INITIAL FIRE SAFETY INSPECTION REPORT

Factory Name: Life Textile Pvt. Ltd. Extension

RSC ID: 24597

Date: 18-September-2023

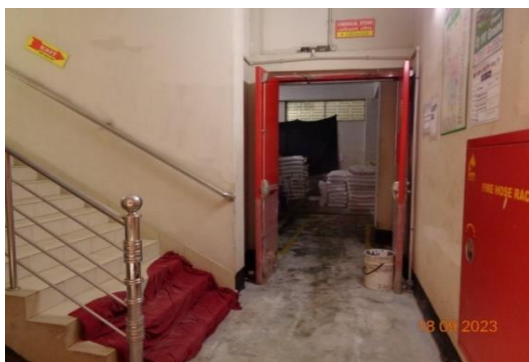
SI No.	Category	Findings	Required Action	Remediation Time Frame
F-1	Fire Rated Construction	Chemical storage area is not separated by fire-rated construction having non rated door and unsealed penetrations and openings. Location: Ground floor.	Separate the chemical storage room by 2-hr fire rated construction. Seal all penetrations and protect the openings to maintain the required fire separations. Keep 16-points MSDS of all chemicals in the storage area. ** As per BNBC, chemical storage room will be Type-1 construction.	Within 3 Months

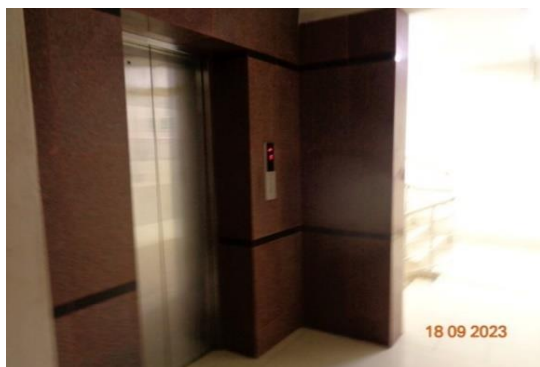
F-2	Fire Rated Construction	Elevator shaft is not separated by proper fire rated construction (openings, non-rated doors, penetrations) Lift open to floor and elevator shaft near stair 1.	In new and interim construction, an exit stairway shall not be built around a lift shaft unless both of them are located in a smoke proof enclosure and made of a material with fire resistance rating required for the type of construction of smoke proof enclosure as per RSC-6.14.3. So, separate the stair enclosure from elevator shaft throughout the building.	Within 3 Months
-----	-------------------------	---	--	-----------------

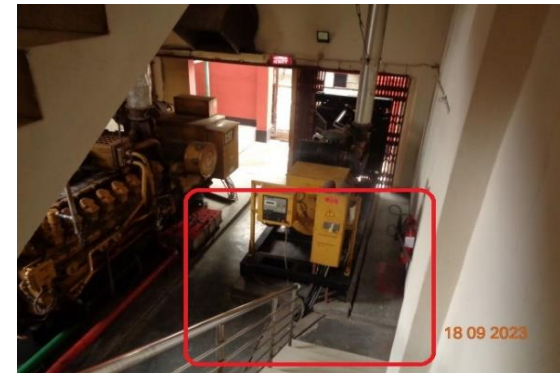
F-18	Fire Rated Construction	Exit stairs are not properly separated from the building and stair exit discharge. Location: Knitting and generator building.	Separate the exit stairs from work areas and other building spaces on all floor levels by minimum 2- hr fire-rated construction. Provide minimum 1.5- hr fire rated doors and seal all unprotected openings and penetrations to maintain the fire separation (10" wall). Ensure that all fire doors are self-closing and positive latching, and are provided with fire exit (panic) hardware where serving production floors or assembly occupancies. If fire doors are required to be held open for functional reasons, provide automatic-closing devices tied to the fire alarm system. Once fire doors are installed, every door in a stair enclosure serving more than 5 stories shall be provided with re-entry unless it meets RSC 6.8.3.1.	Within 3 months
------	-------------------------	--	---	-----------------
